V1_Site Development Plan_COMMENTS.pdf Markup Summary

PROJECT INFORMATION:
 PCD NO: PPR2610
 TAX SCHEDULE NO: 550000164
 PROPERTY ADDRESS: 6155 FOUNTAIN VALLEY SCHOOL ROAD
 CURRENT ZONING: A-5, CAD-O(ANAV)
 PROPOSED ZONING: A-5
 PROPOSED LAND USE: PRIVATE EDUCATIONAL INSTITUTION
 PROPOSED BUILDING(S) USE: ACADEMIC
 PROPERTY AREA: 9.37 AC

FOUNTAIN VALLEY SCHOOL
 ACADEMIC CENTER

SITE DEVELOPMENT PLAN

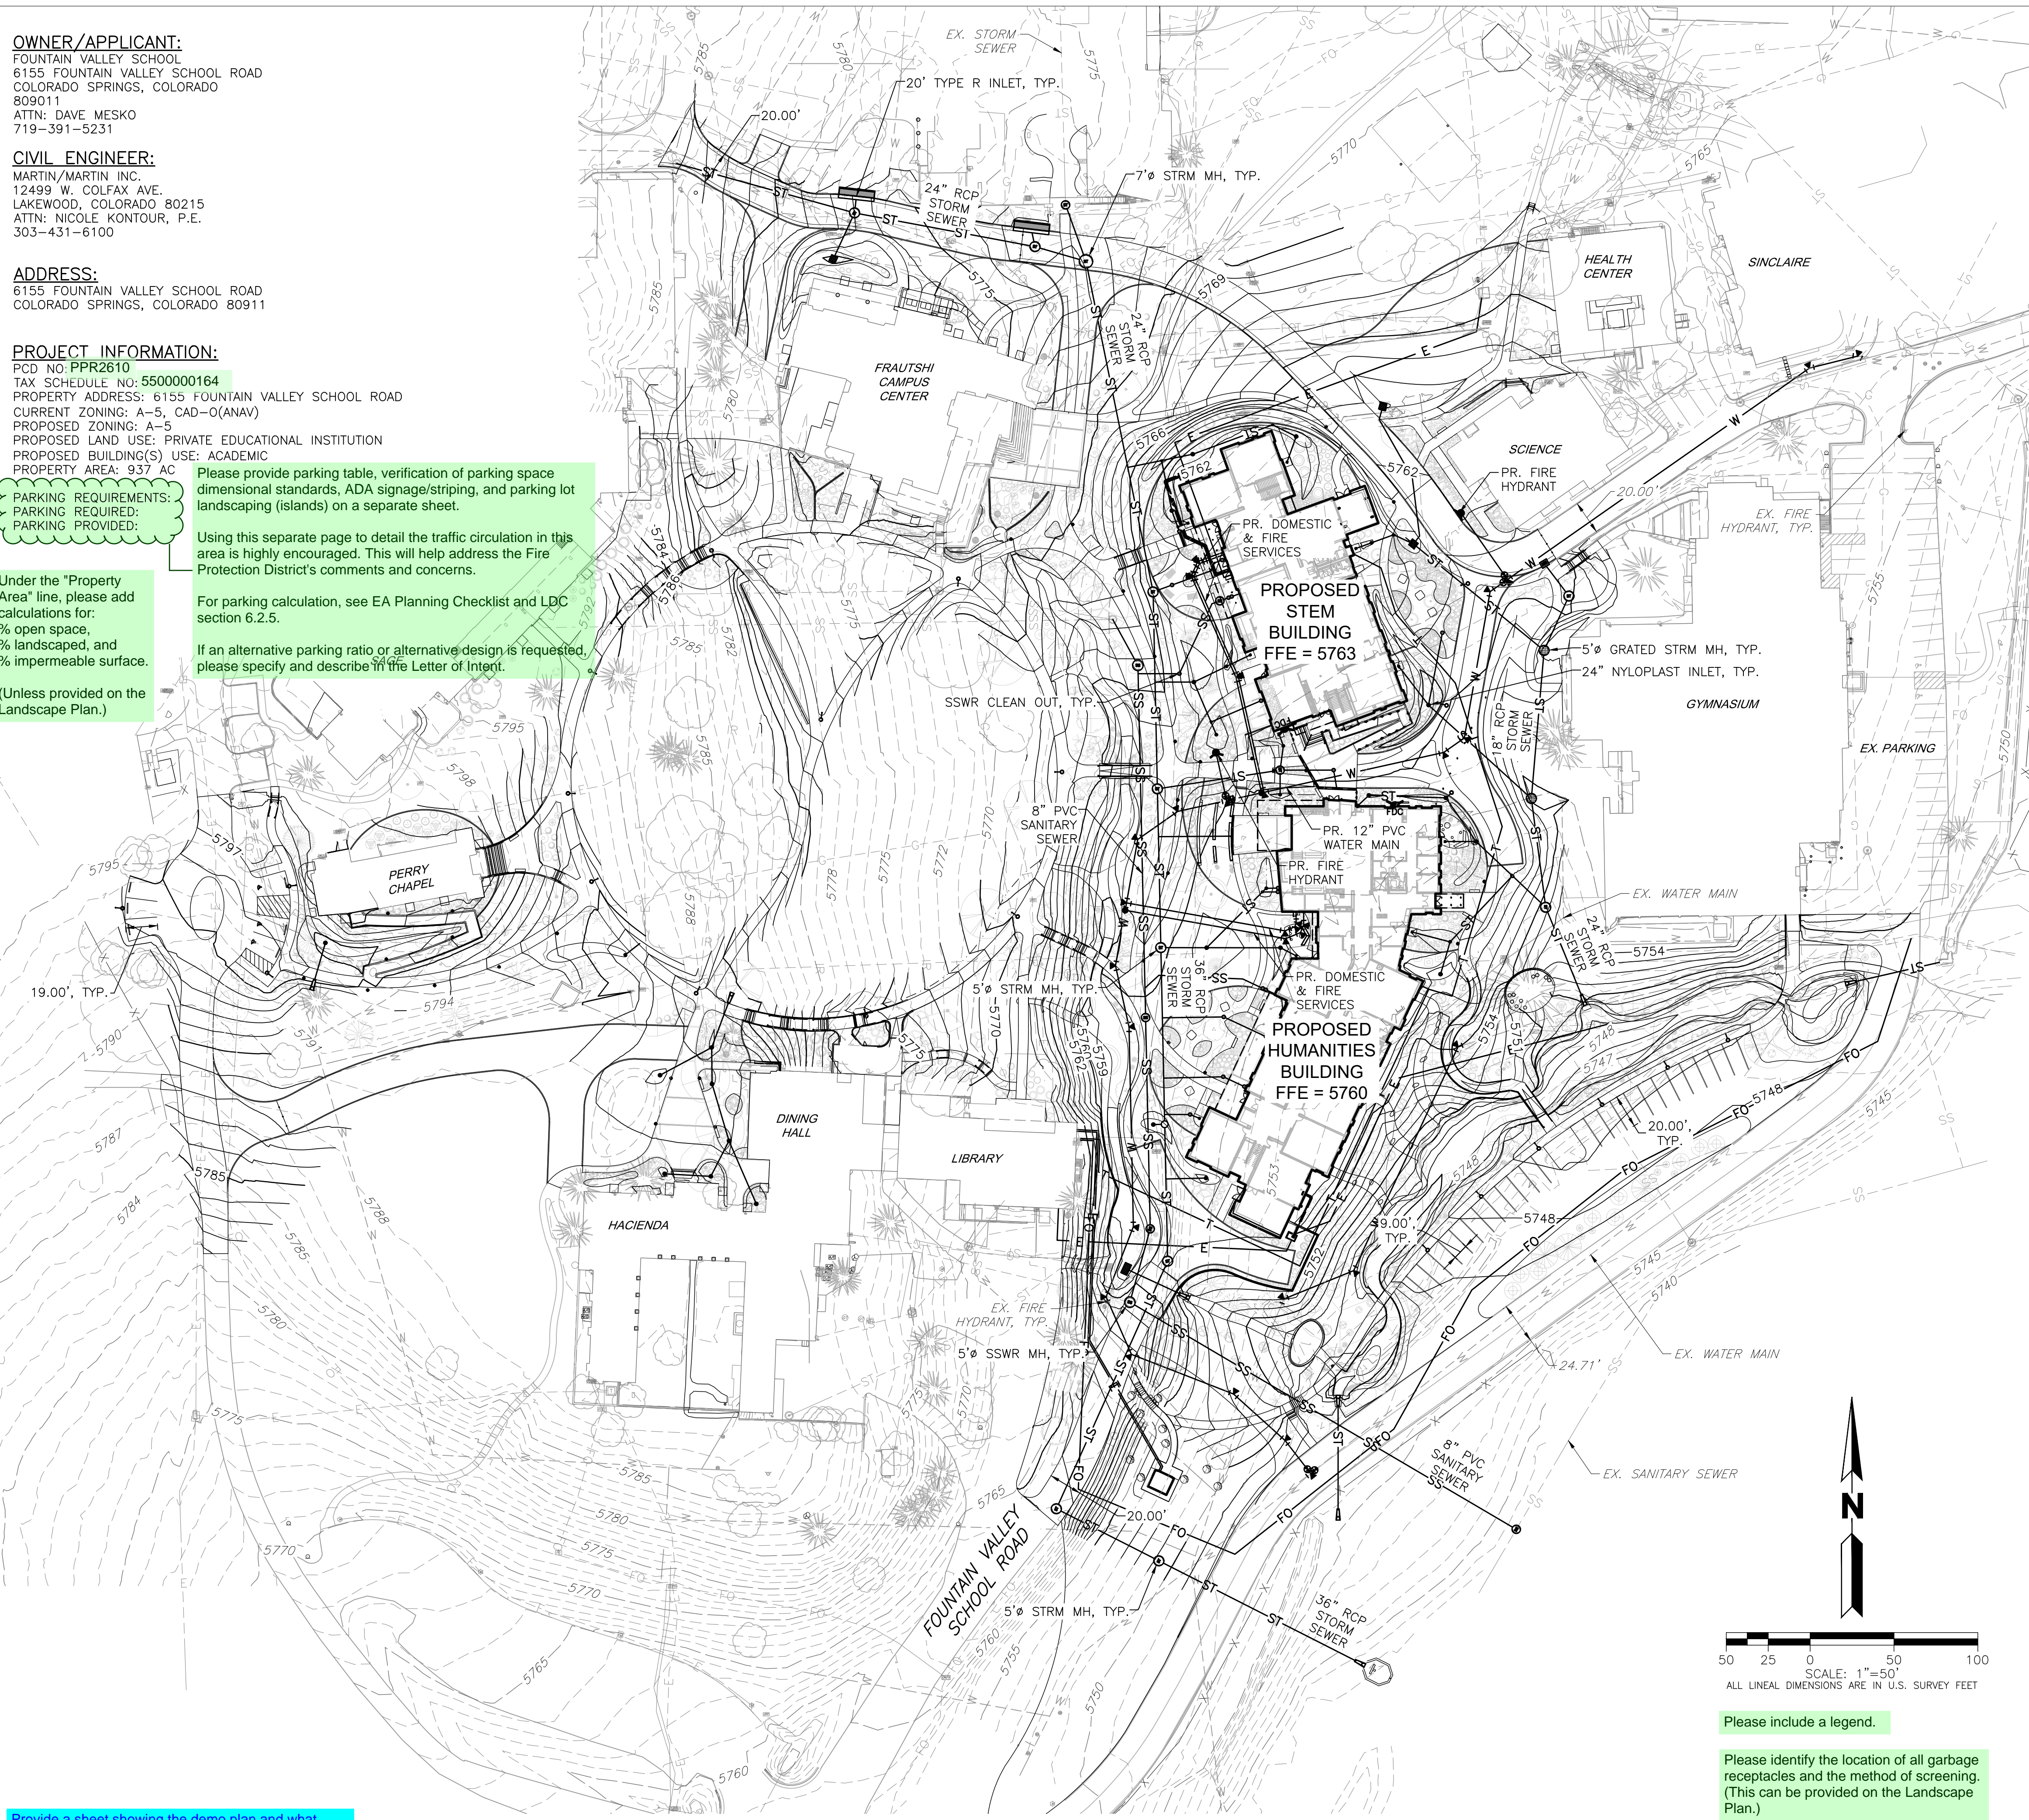
Please provide parking table, verification of parking space dimensional standards, ADA signage/stripping, and parking lot landscaping (islands) on a separate sheet.

Using this separate page to detail the traffic circulation in this area is highly encouraged. This will help address the Fire Protection District's comments and concerns.

For parking calculation, see EA Planning Checklist and LDC section 6.2.5.

If an alternative parking ratio or alternative design is requested, please specify and describe in the Letter of Intent.

Under the "Property Area" line, please add calculations for:
 % open space,
 % landscaped, and
 % impermeable surface.

(Unless provided on the Landscape Plan.)

Provide a sheet showing the demo plan and what buildings are being removed. Include GSF of each building being demo'd

Please include a legend.
 Please identify the location of all garbage receptacles and the method of screening. (This can be provided on the Landscape Plan.)
